MODEL  
2018MY  
Rio (SC)

NUMBER  
PS671

### POTENTIAL LOW OIL PRESSURE DUE TO DOWEL PIN NOT FULLY SEATED

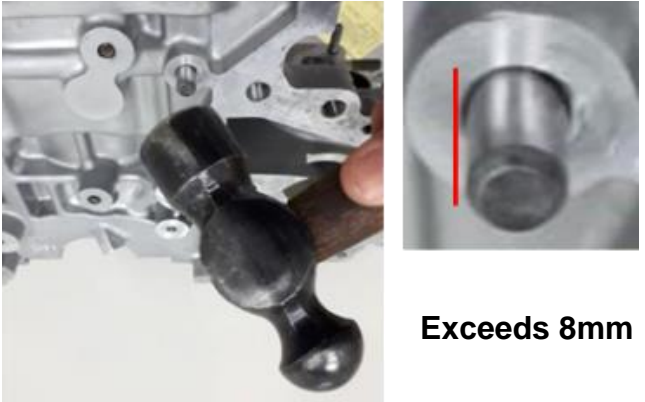
This Pitstop provides information regarding a potential low oil pressure warning light 'ON' on some 2018MY Rio (SC) vehicles, produced from August 3, 2017 through November 6, 2018, which may be due to the oil pressure leaking past the timing tensioner chain dowel pin. If the dowel pin is not fully seated as described in this publication, measure and adjust the pin height as required between 7-8mm (pin length is 14mm).

Good	No Good
	 <p><b>Exceeds 8mm</b></p>
Measures 7-8mm. OK.	Measures 9mm>. Adjust as required.

**Note: If the dowel pin measures less than 6mm, replace the engine block due to incorrect drilling depth. Confirm proper authorizations prior to block replacement.**
